Los Angeles Regional Water Quality Control Board

REVIEW OF THE DOMINGUEZ CHANNEL WATERSHED MANAGEMENT AREA GROUP'S DRAFT COORDINATED INTEGRATED MONITORING PROGRAM, PURSUANT TO PART VI.B AND ATTACHMENT E PART IV.B OF THE LOS ANGELES COUNTY MUNICIPAL SEPARATE STORM SEWER SYSTEM (MS4) PERMIT (NPDES PERMIT NO. CAS004001; ORDER NO. R4-2012-0175)

Enclosure 1 – Summary of Comments and Necessary Revisions to Draft CIMP

Figure 6

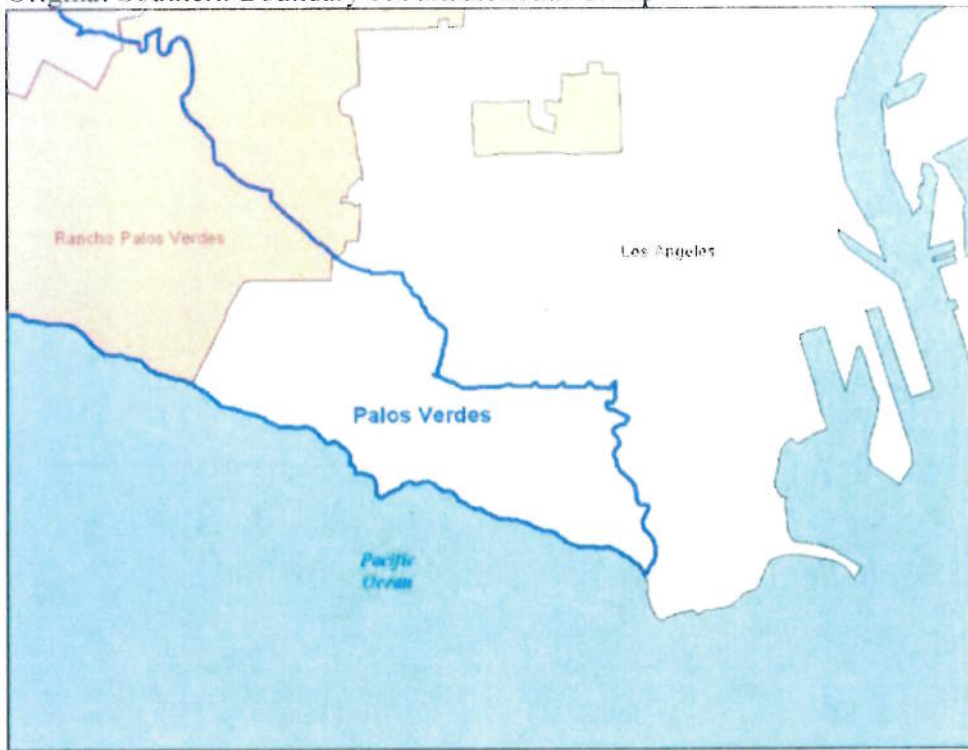
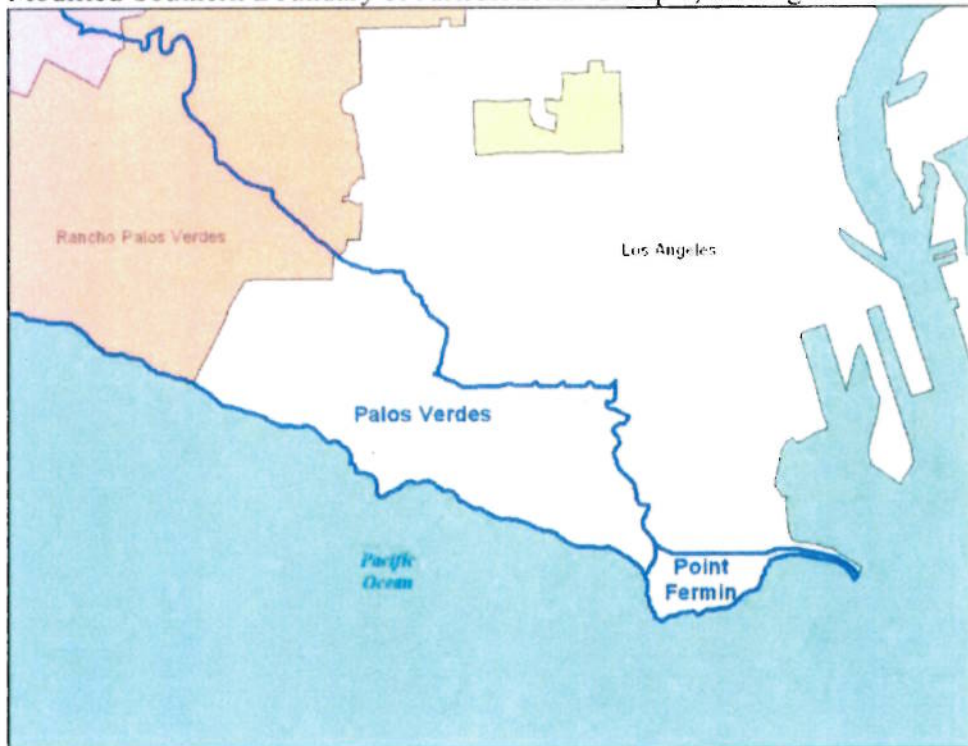
CIMP Reference	MRP Element/ Reference (Attachment E)	Comment and Necessary Revision
Receiving Water Monitoring		
Section 1.1 (Watershed Management Plan Area)	Part VI.B.2	<p>The EWMP workplan and CIMP indicate that the DC WMA Group’s jurisdictional area includes Point Fermin at the southernmost tip of the watershed. This is consistent with the watershed boundary indicated in Attachment B (Figure B-3) of the MS4 Permit.</p> <p>However, the Point Fermin area was actually added to Santa Monica Bay Jurisdictional Group 7 in January 20, 2004 (see Attachment to this Enclosure). As part of Jurisdictional Group 7, Point Fermin is subject to the Santa Monica Bay Beaches Bacteria TMDLs and the associated Coordinated Shoreline Monitoring Plan.</p> <p>Therefore, the Group should note the different watershed for this area, and cite the applicable TMDLs and associated TMDL monitoring in their revised CIMP.</p> <p>Alternatively, the Group may consider coordinating with the Santa Monica Bay Watershed Jurisdiction 7 WMP Group and redefining EWMP boundaries to match the applicable subwatershed boundaries of the Santa Monica Bay Beaches Bacteria TMDLs.</p>
